MEMORANDUM FOR: Thomas Novak, Assistant Director for Licensing
FROM: Darrell G. Eisenhut, Director
Division of Licensing
SUBJECT: BOARD NOTIFICATION NO. 83-144

SUBJECT: STAFF EVALUATION OF THE CE PORV ISSUE

STAFF EVALUATION OF THE NEED FOR A RAPID

DEPRESSURIZATION CAPABILITY FOR CE PLANTS

Figure D-1 Value/Impact versus Change in Risk Matrix

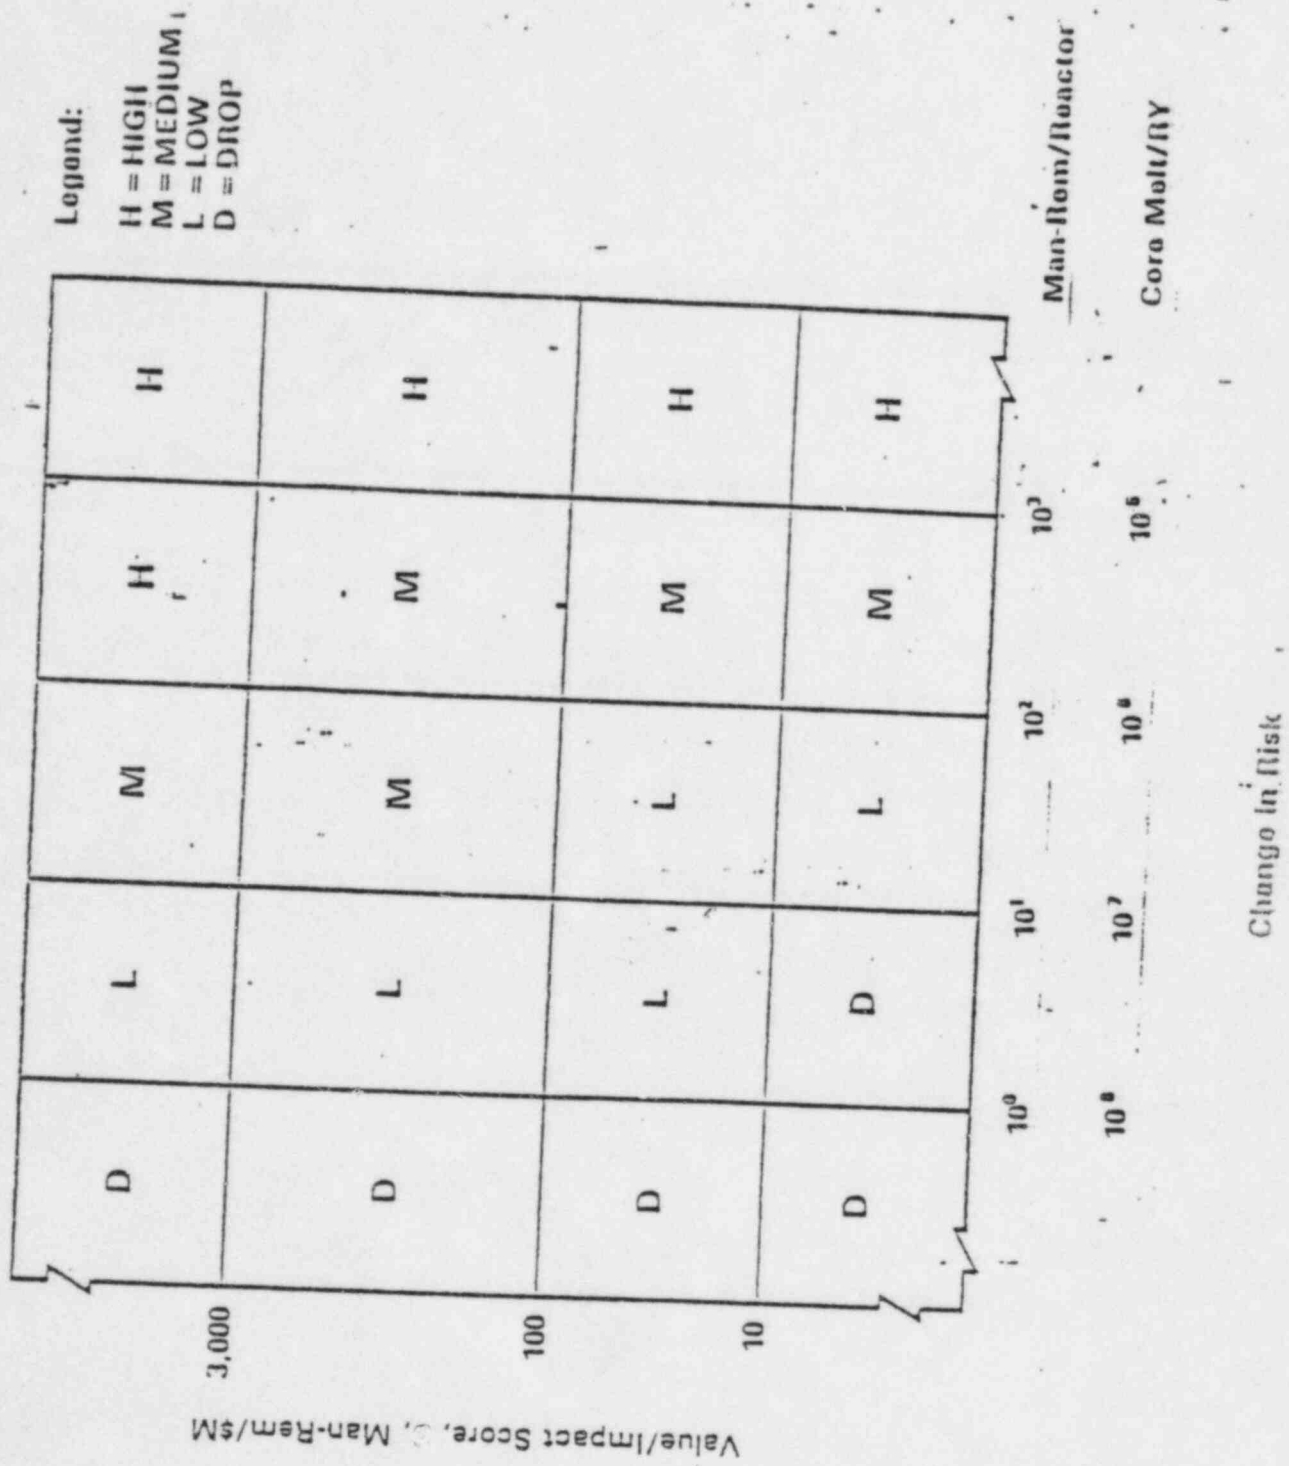
If we consider the NET VALUE/IMPACT, as shown in Table D-3, the S score is approximately 25 man-rem/\$million. However, in either case, as evidenced from Figure D-1, the resultant "S" score provides only a marginal value/impact if compared to the ALARA goal of 1000 man-rem averted per \$million (i.e., reciprocal of \$1000 per man-rem).

Note that in Figure D-1, the risk reduction (or safety benefit) scales are shown orthogonal to the value/impact (or "S" score) scale. For the SONGS site, the "S" score does not change if Units 2 and 3 are considered either separately or combined. Likewise, the change in core melt frequency shown in the risk scales of Figure D-1 is reactor specific. Examination of Figure D-1 shows that for a reduction in core melt frequency of 10^{-5} /Ry, for any

FIGURE A1-1
 SIMPLIFIED SCHEMATIC OF SONGS CVCS SHOWING AUXILIARY
 SPRAY PORTION AND SOURCES OF BORATED WATER

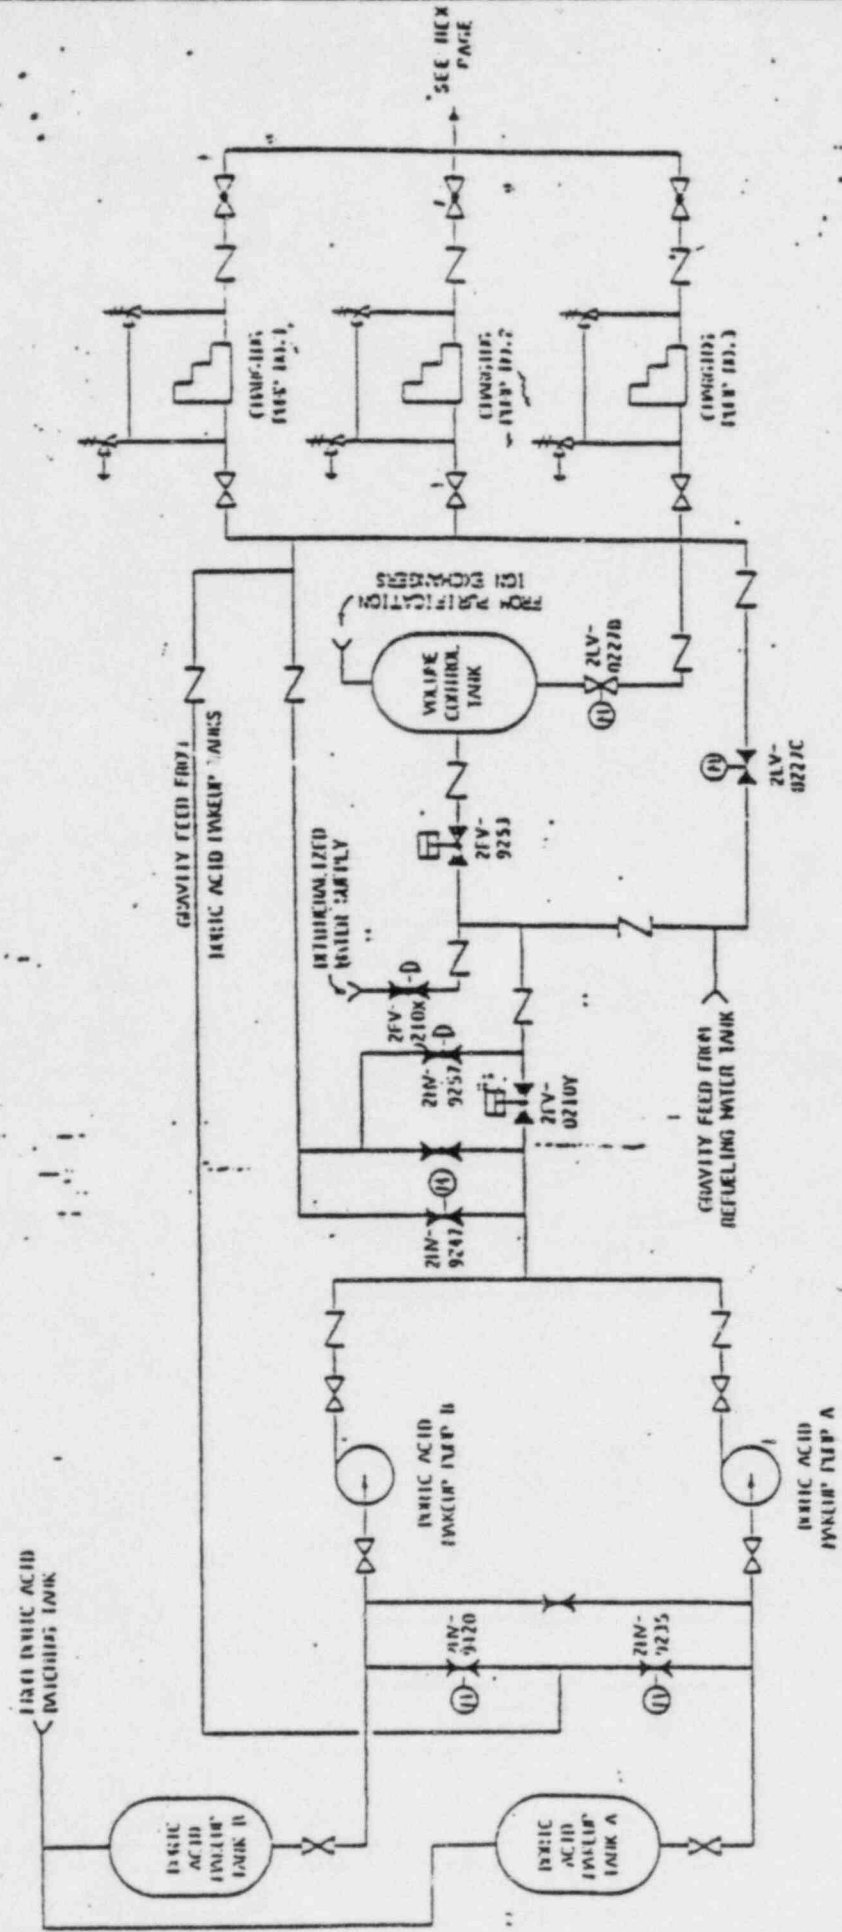
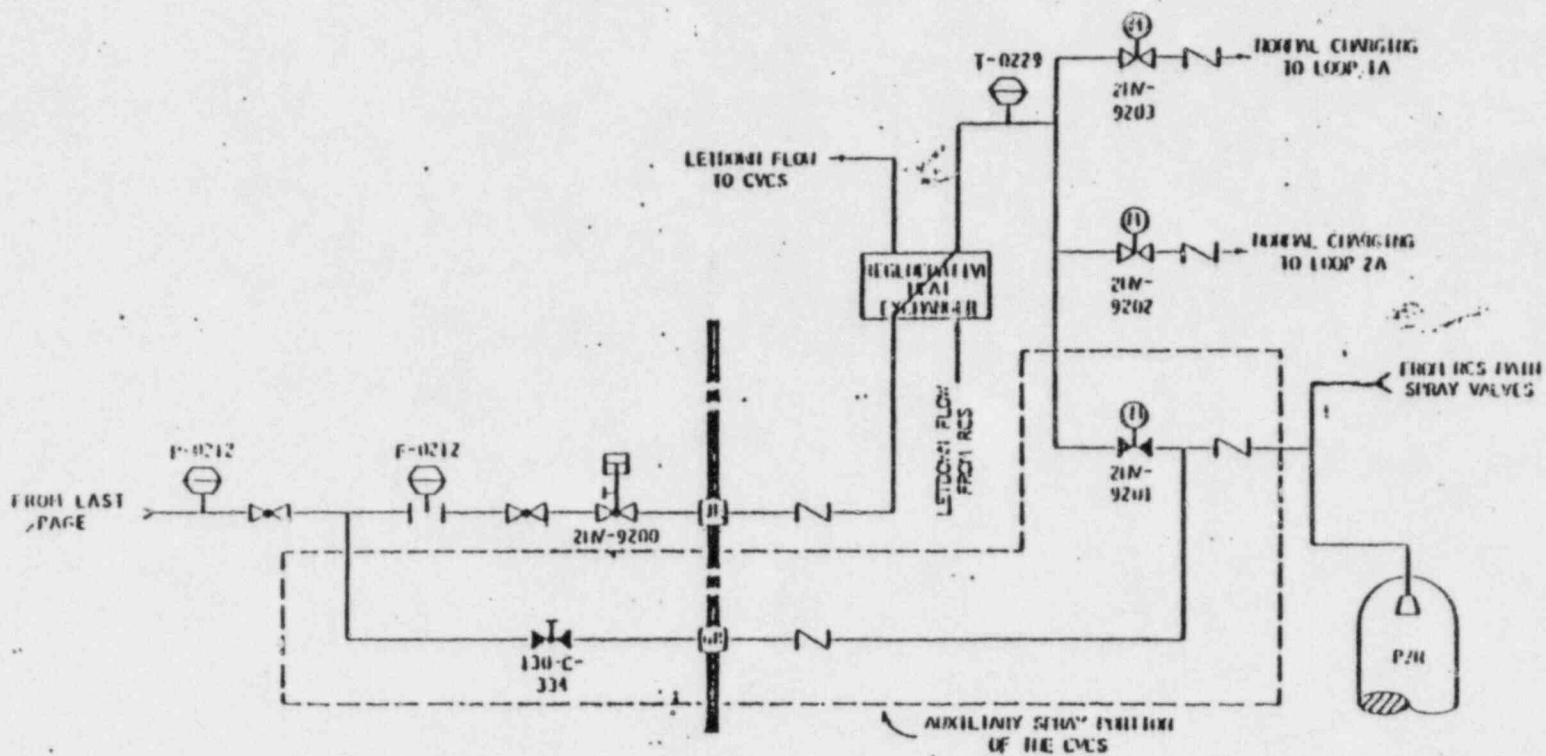
The configurations of the APS for SONGS Units 2 and 3 is shown in Figure 2.1-2 of CEN 239 (Figure A1-1 and A1-2). The APS flow is initiated from the control room by opening the auxiliary spray valves (2HV-9201) ensuring the two main spray valves are closed and closing the two loop charging valves (2HV-9202 and 2HV-9203). For SONGS 2 & 3, the charging pumps are automatically started after they are automatically loaded to the diesels following a loss of offsite power. In the event that either the auxiliary spray valve (2HV-9201) fails to open or one of the loop charging valve fails to close, a bypass line has been provided with a manually operated auxiliary spray valve (130-C-334) could be initiated from outside containment. In this APS design, a potential vulnerability was identified. One of the two main spray valves failing to close could cause insufficient APS flow to the pressurizer. This staff concern was not addressed in the response to Staff Question No. 1. In the meeting of July 7, 1983 with

FIGURE A1-3
 SIMPLIFIED SCHEMATIC OF WATERFORD CVCS SHOWING AUXILIARY
 SPRAY PORTION AND SOURCES OF BORATED WATER¹

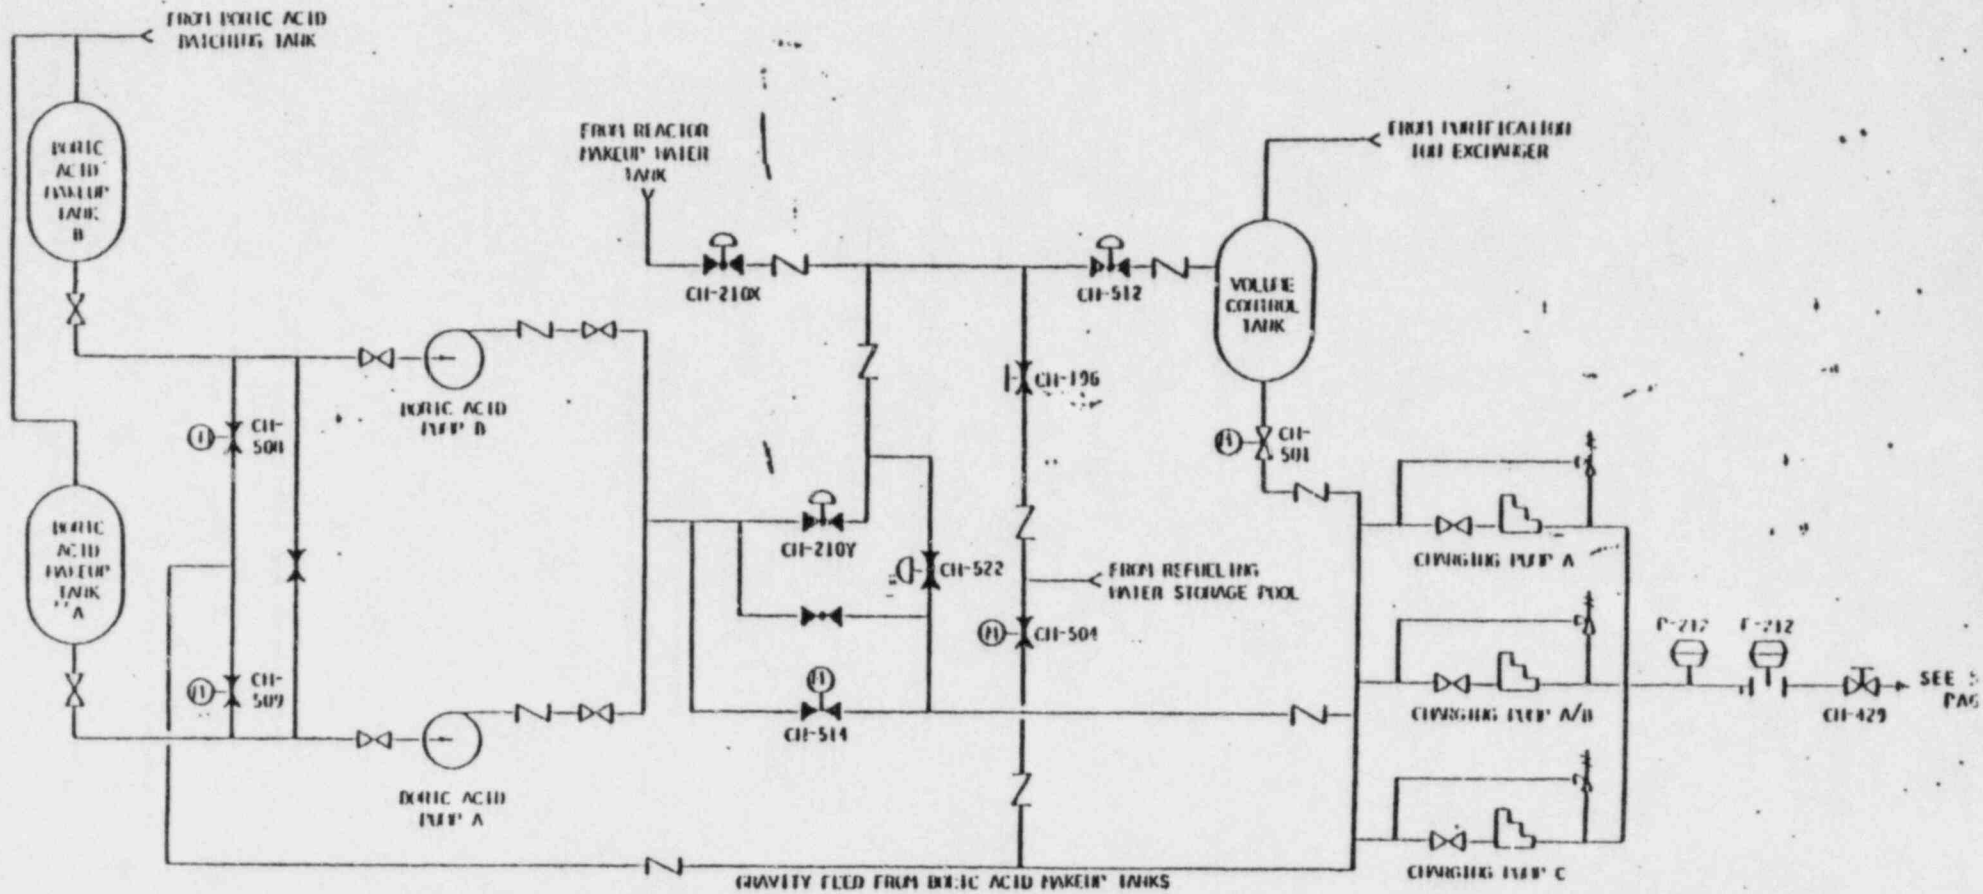
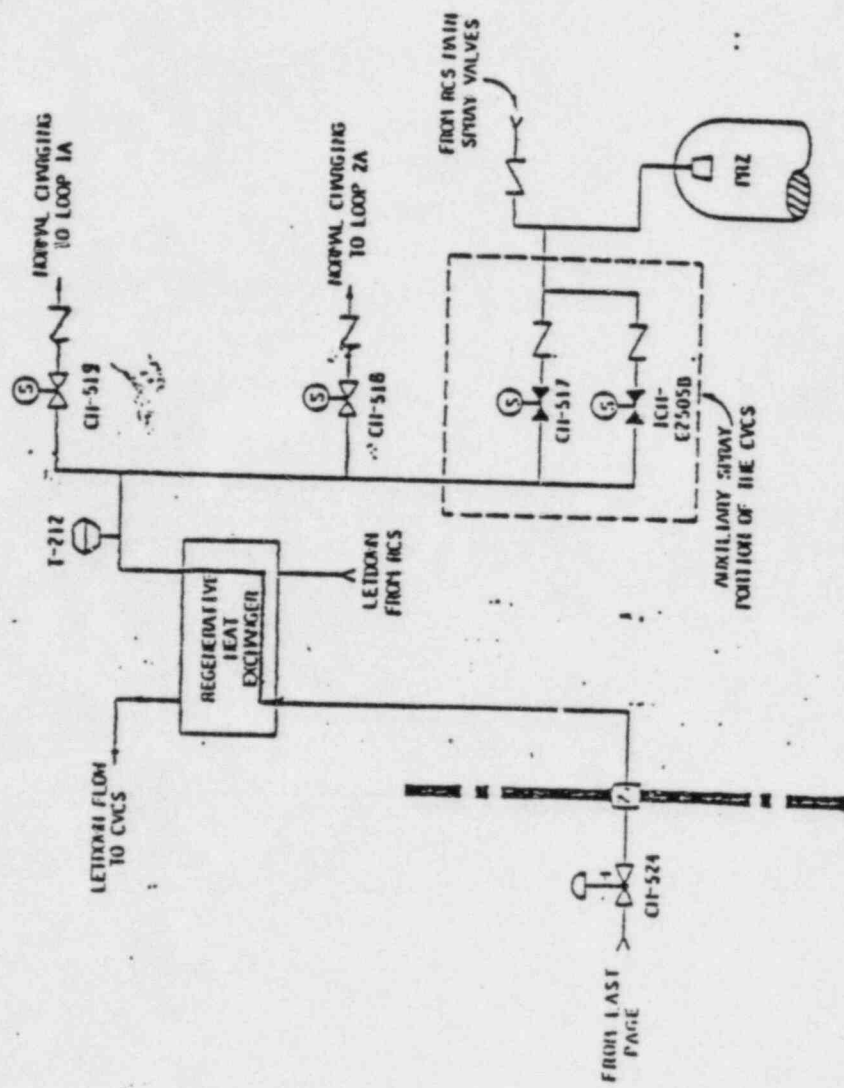
The configurations of the APS for Waterford 3 is shown in Figure 2.1-3 of CEN 239 (Figure A1-3 and A1-4). The APS flow is initiated from the control room by opening one of the redundant auxiliary spray valves (CH-517 or ICH-E2505B) and closing the two loop charging valves (CH-518 and CH-519). A check valve has been provided in the main spray piping to prevent APS flow back into the main spray line in case a single active failure of the main spray valve. The charging pumps A and B are automatically started after they are automatically loaded to the diesels. The two loop charging valves which must be closed in order to prevent flow into the RCS loops during auxiliary spray operations, are Class IE solenoid valves which are designed to fail in the closed position upon loss of motive power. The control system for these valves is a control grade system, and the valves do not receive an SIAS signal for automatic closure upon ECCS initiation. Further, if one of the valves control system went to the full open position, insufficient charging flow to the pressurizer would result. The staff believes the current design is such that the loop charging valves could fail into fully open position due to a control system failure and thus cause insufficient APS flow toward pressurizer.

FIGURE A 1-5
 SIMPLIFIED SCHEMATIC OF PALO VERDE CYCS SHOWING AUXILIARY
 SPRAY PORTION AND SOURCES OF BORATED WATER

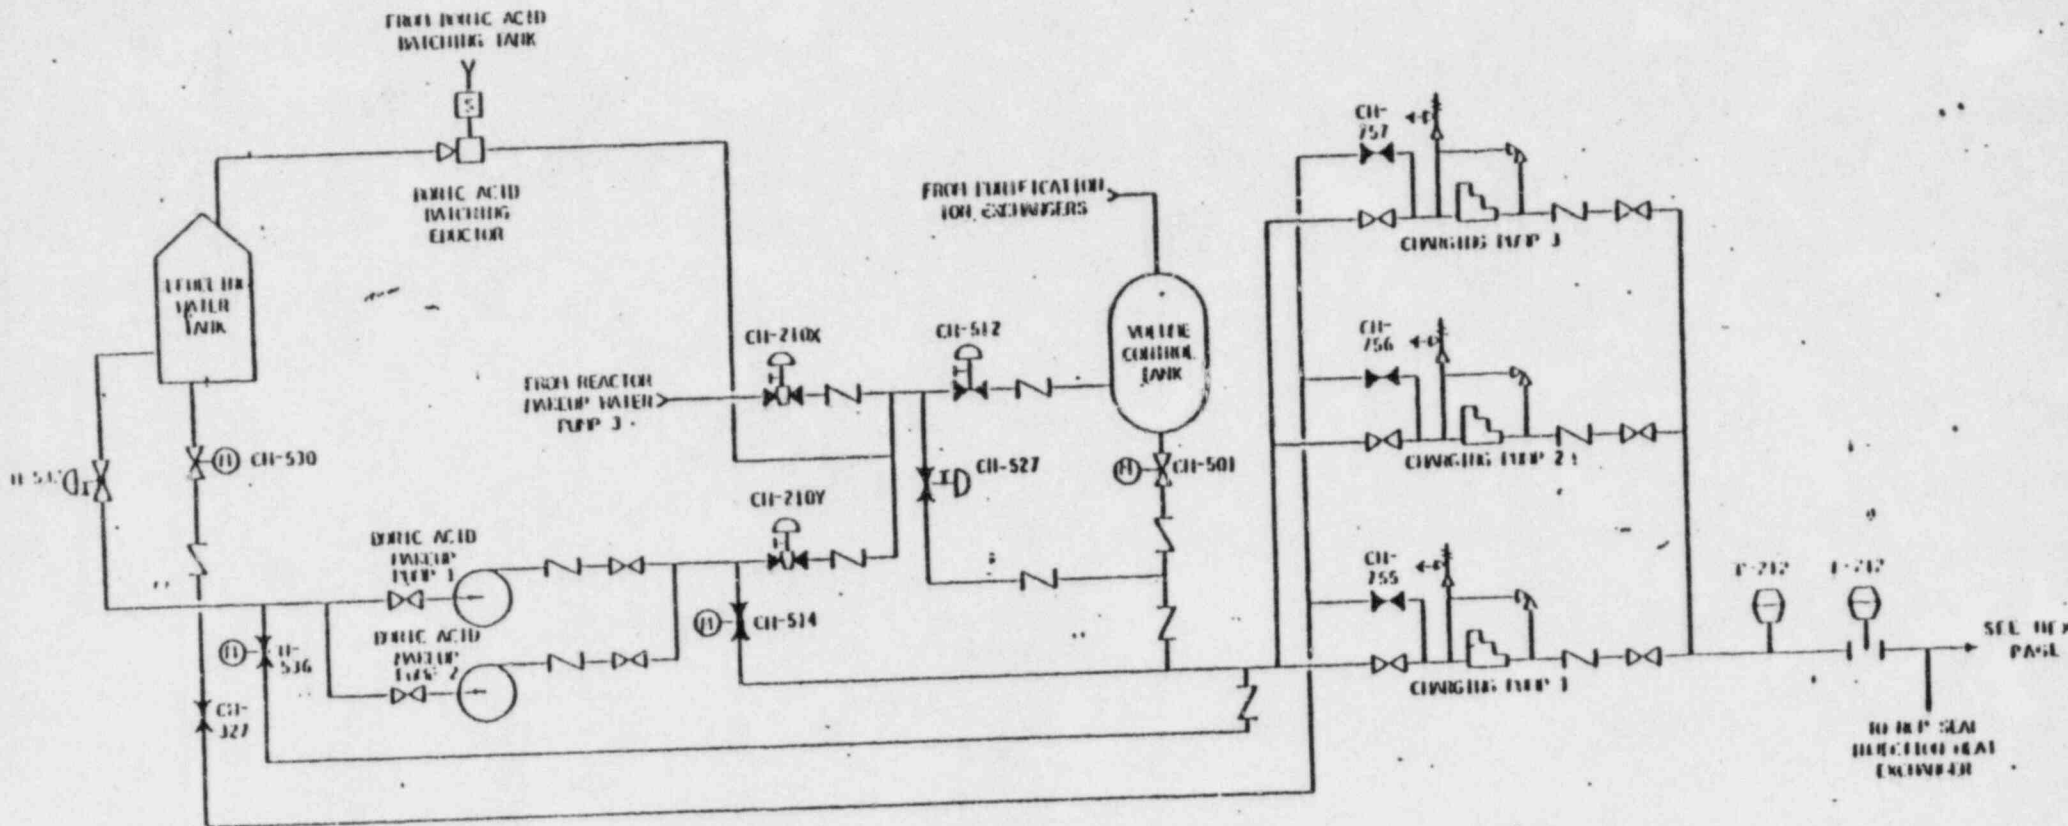
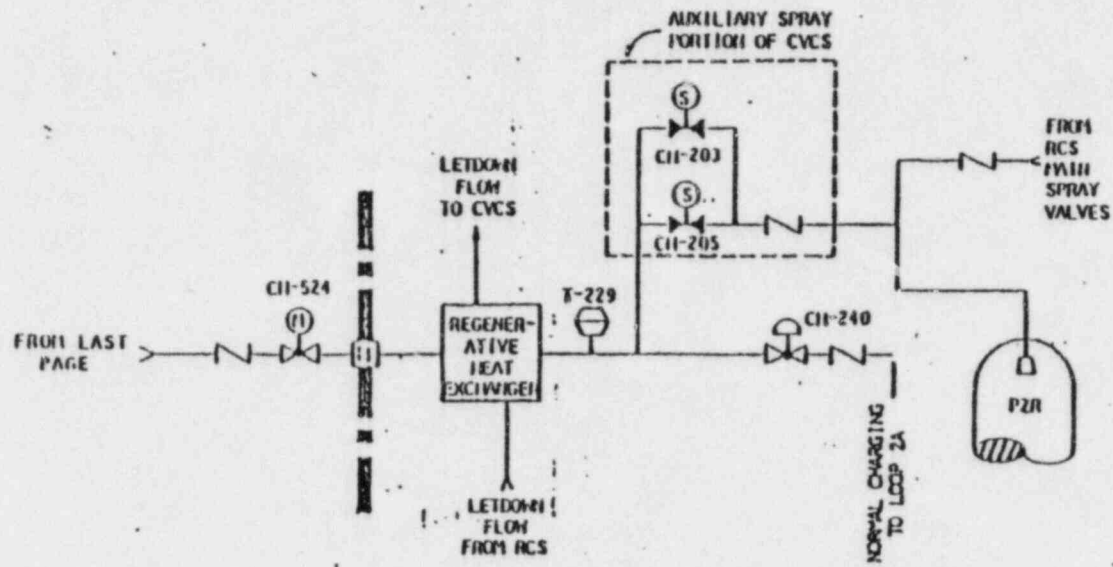
The configurations of the APS for CE system 80 plants (Palo Verde 1, 2 and 3, WPPSS 3) are shown in Figures 2.1-4 and 2.1-5 of CEN 239 (Figure A1-5 and A1-6). The APS flow is initiated from the control room by opening one of the redundant auxiliary spray valves (CH-203 or CH-205) and closing the loop charging valve (CH-240). A check valve has been provided in the main spray piping to prevent APS flow back into the main spray line in case a single active failure of the main spray valve. The charging pumps are manually initiated after they are automatically loaded to the diesels. The loop charging valve (CH-240) which must be fully closed in order to get full auxiliary spray flow is air operated with a Class IE Solenoid. The valve is designed to fail closed on loss of air and loss of power to the solenoid. However, as in the Waterford 3 design, the system controlling the charging valve's position is a control guide system, and the valves do not receive an SIAS signal for autoclosure upon ECCS initiation. Further, if the valve (CH-240) went to a full open position, insufficient spray flow would result. The staff believes the current design is such that the loop charging valve could fail into fully open position due to a control system failure and thus cause insufficient APS flow toward pressurizer.

on the functioning of a control grade system. The staff notes that, unlike the loop charging valves, malfunctions in the seal injection portion of the charging system can be corrected by manual valve operation outside containment. However, the staff continues to believe that safety systems should not require local, manual operation of a control system and these deficiencies should be corrected. However, the flow to the RCP seals is less than the flow to the loops should the loop charging valves fully open. Thus the impact on APS performance would be less due to malfunctions in the RCP injection line.
